STATE OF NEW HAMPSHIRE
INTRA-DEPARTMENT COMMUNICATION

SUBJECT: MISC. ENG DISTRICT 5
1832-I
Hudson, NH Route 3A (Lowell Road)
Proposed Logistics Center (Amazon)

MEMORANDUM

Re: Response to TIS Comments
 Hudson Logistics Center
 Hudson, NH
 Langan Project No.: 151010101

Figure 3B-11. Examples of Applications of Conventional Road Lane-Drop Markings (Sheet 1 of 2)

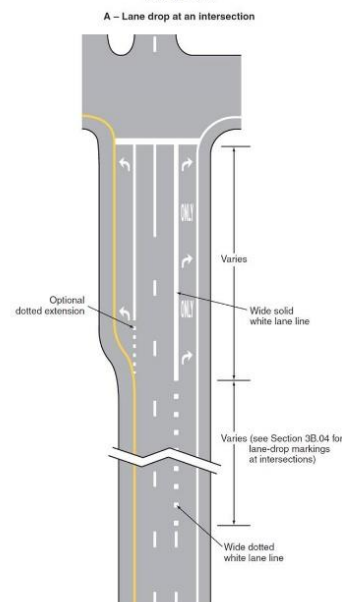
3. The proposed geometry along NH 3A results in three "trap" lanes (where a through lane becomes an exclusive turning lane):
- Northbound through lane at Walmart Boulevard becomes an exclusive left turn lane at Sagamore Bridge Road
 - Southbound through lane at Walmart Boulevard becomes an exclusive right turn lane at Green Meadow Drive
 - Southbound through lane at Green Meadow Drive becomes an exclusive left turn lane at Dracut Road.

Trap lanes are undesirable from a safety perspective. The consultant should investigate ways to eliminate the trap lane geometry. If this is not feasible, measures to mitigate the safety concern should be presented.

Southbound through lane at Walmart Boulevard becomes an exclusive right turn lane at Green Meadow Drive. There is not enough room between Walmart Boulevard and Green Meadow Drive to drop the through lane prior to developing an exclusive right turn lane. However, there is enough room to provide advance signing and marking according to Figure 3B-11 A – Lane Drop at an

intersection. The design involves a wide dotted lane line and a sign indicating two through lanes, a right turn only lane and a left turn only lane ahead. In addition, an attempt will be made to provide a traffic island on the Green Meadow approach that will further alert southbound motorists of the right turn only lane ahead. Southbound through lane at Green Meadow Drive becomes an exclusive left turn at Dracut Road. The roadway curvature between Green Meadow Drive and Dracut Road may facilitate restriping the Lowell Road to appropriately drop the outside through lane and develop two left turn lanes off the continuous inside through lane.
